ADDENDUM NO. TWO (2)
TOWN OF BRASELTON, GEORGIA
2026 GROUNDWATER EXPANSION AND DISTRIBUTION STORAGE
ISSUED JANUARY 23, 2026

RE: 2026 GROUNDWATER EXPANSION AND DISTRIBUTION STORAGE
EMI PROJECT No. 18-021

The purpose of this Addendum is to provide the omitted storage tank drawings, existing contours for treatment site, the pre-bid meeting attendance, and add Precon Corporation as a pre-approved concrete storage tank manufacturer. The following items of the Contract Documents are modified as part of this Addendum:

STAINLESS STEEL WALL MANHOLE
(BV#: MAN-CUR-2, CROM REF.: MHC-20x55)
NTS

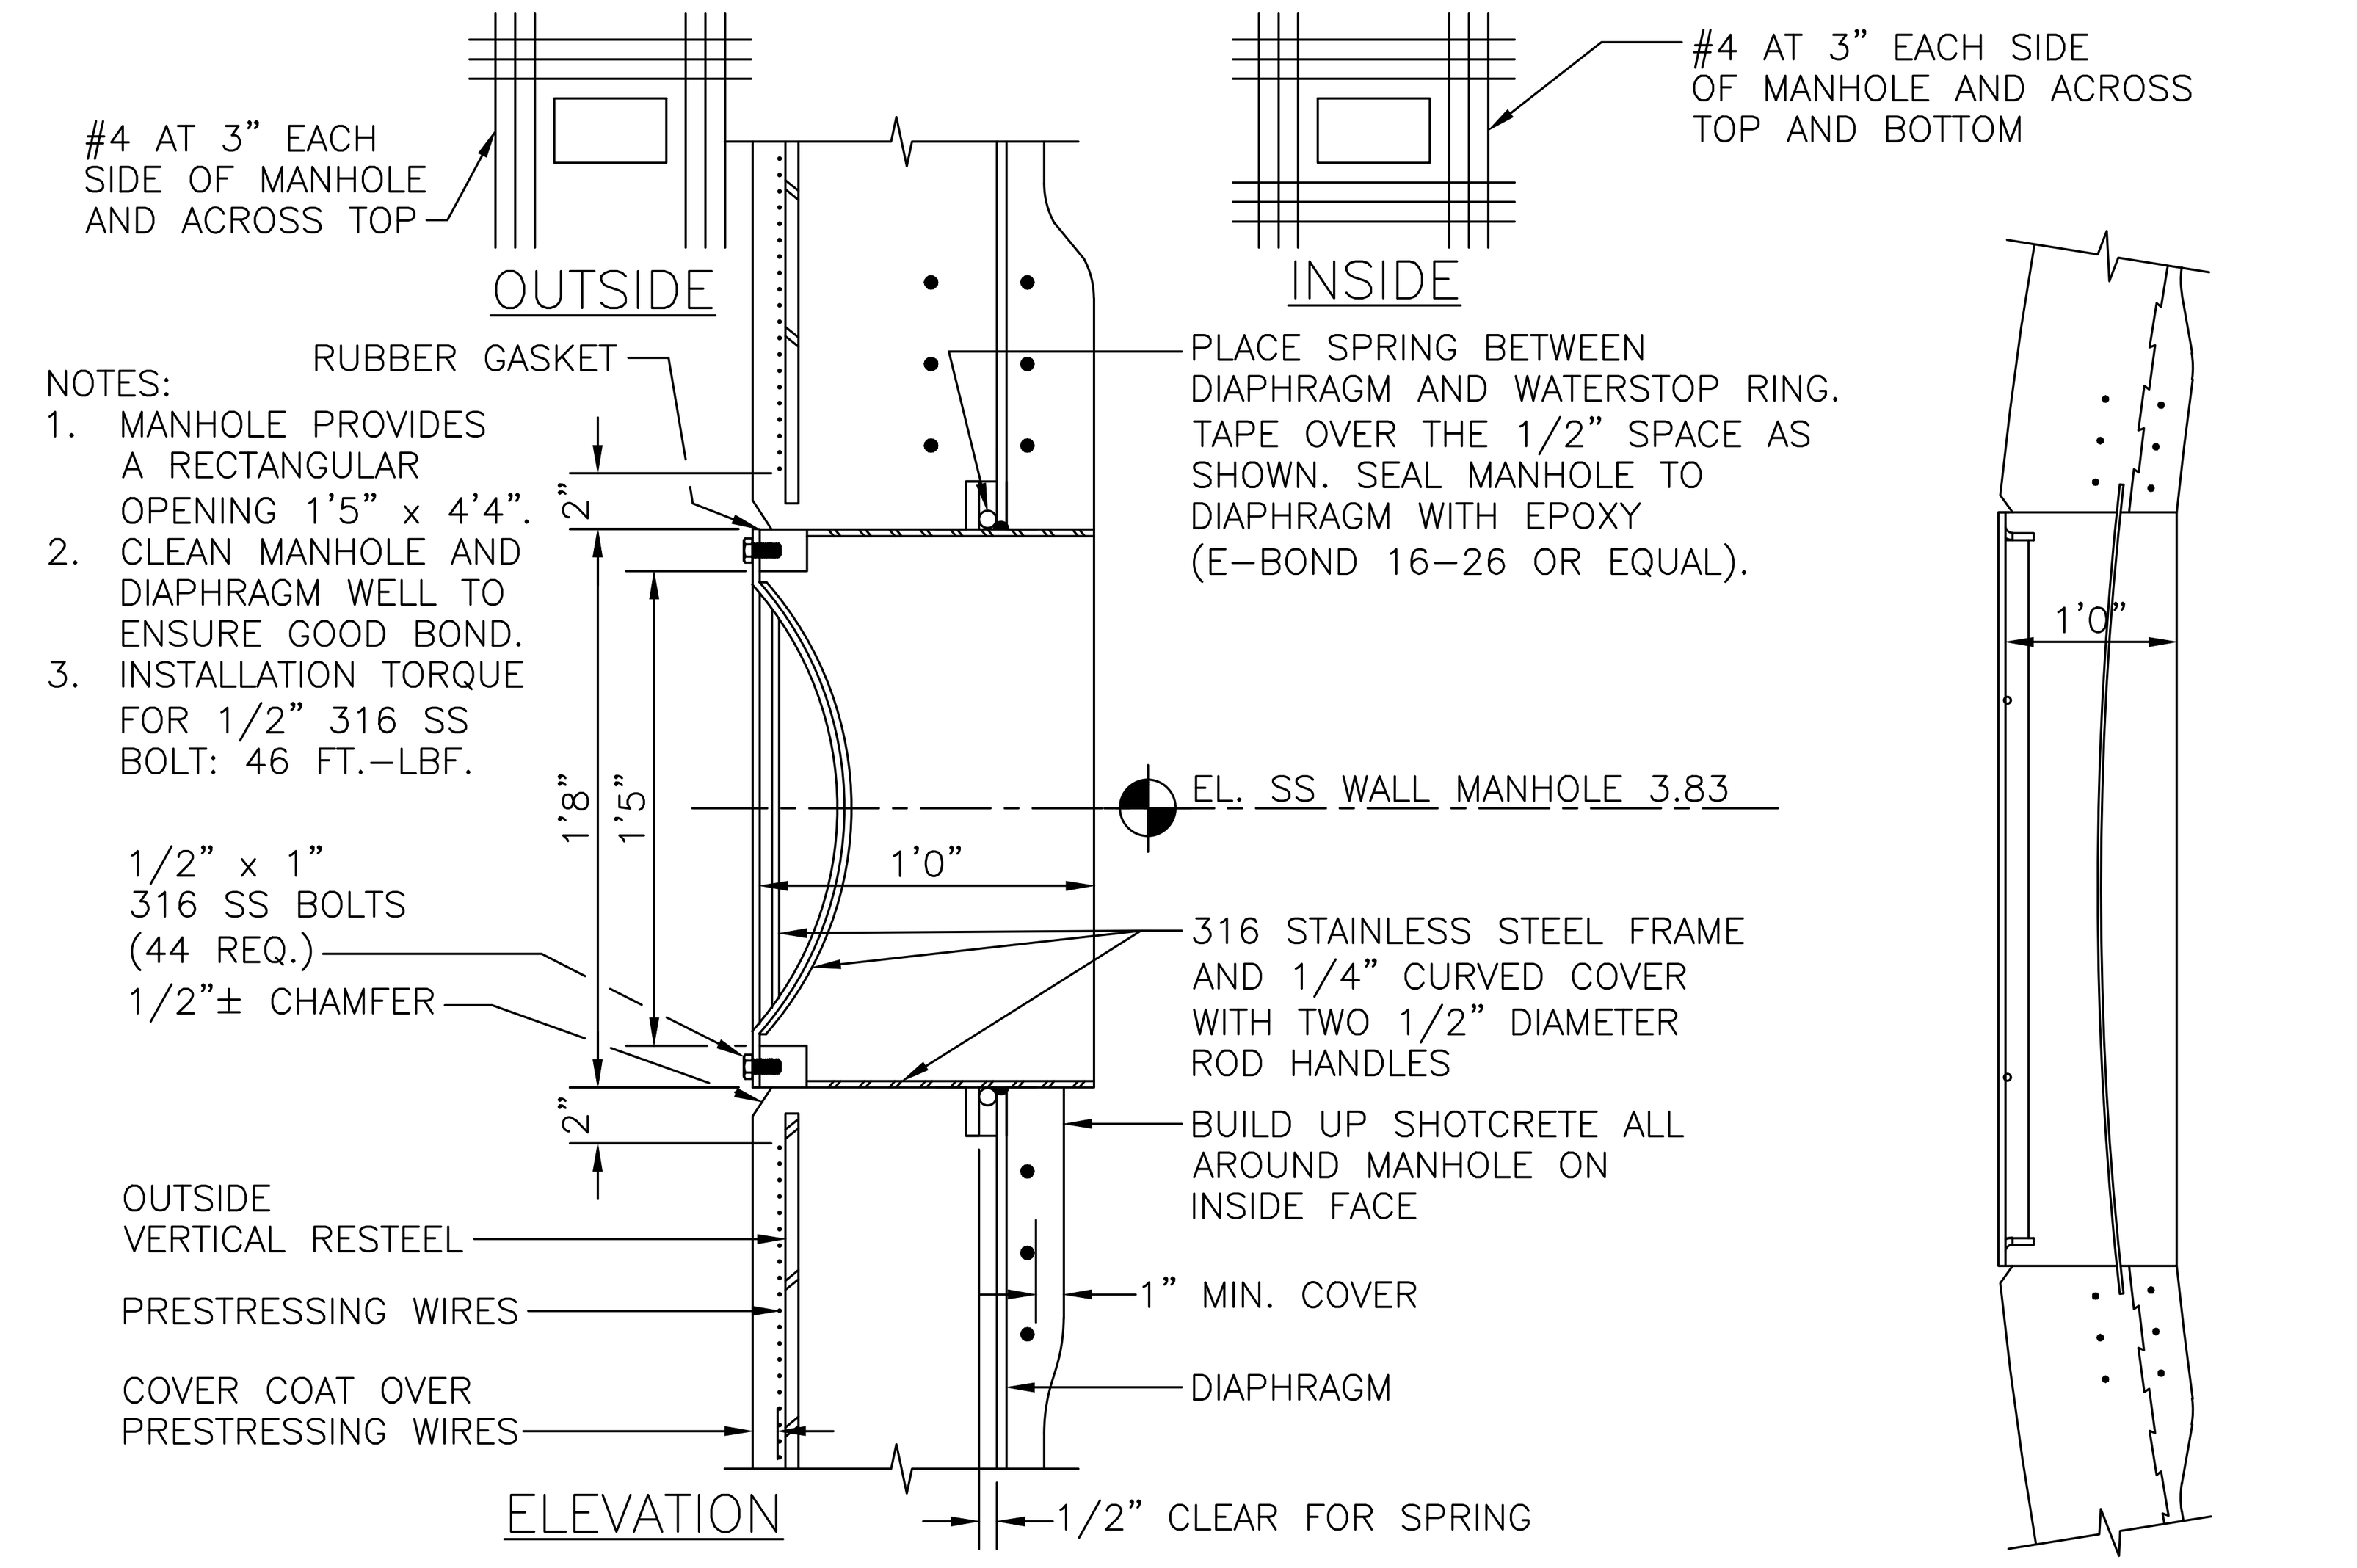
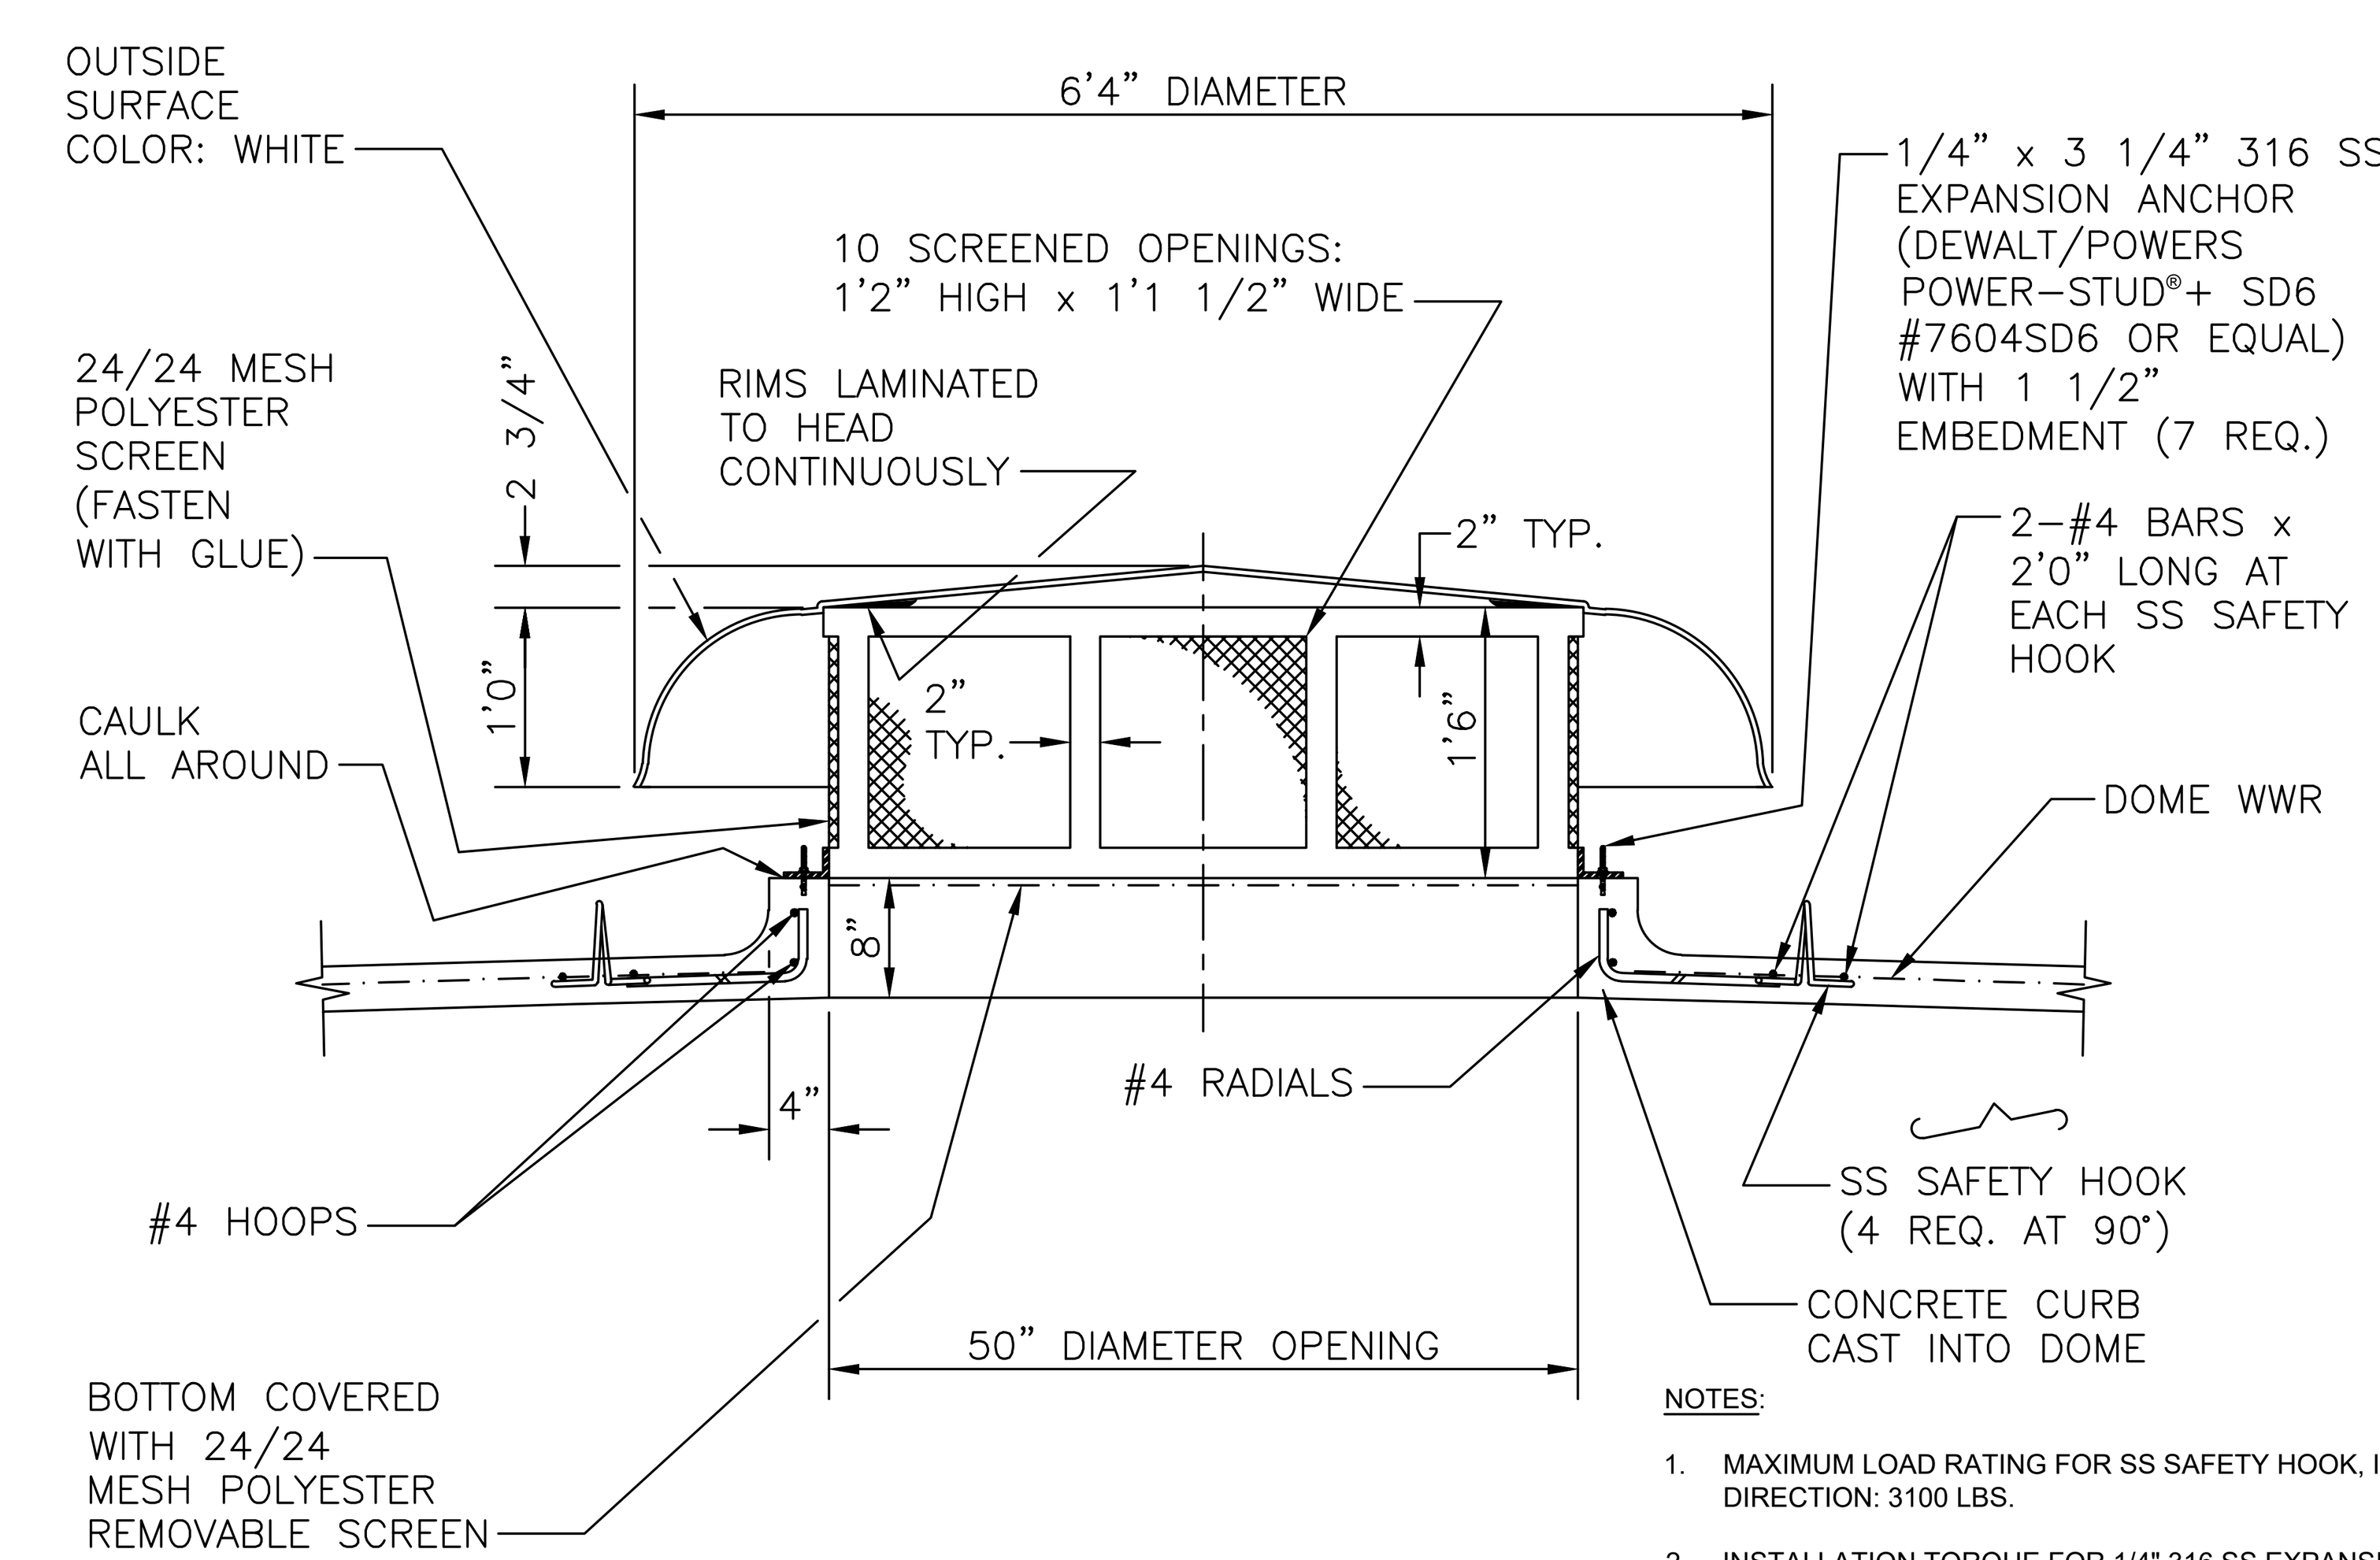
1. The contract documents appear to be missing plan sheets M7-M10 for the new tank listed in the sheet index. Can you please provide the missing drawings?

- <u>*Plan sheets M7-M10 have been provided to show plans for the concrete storage tank. See attached plan sheets.*</u>

EMI Response: Sheets M7-M10 were omitted in error. Please see the original sheets attached to this addendum.
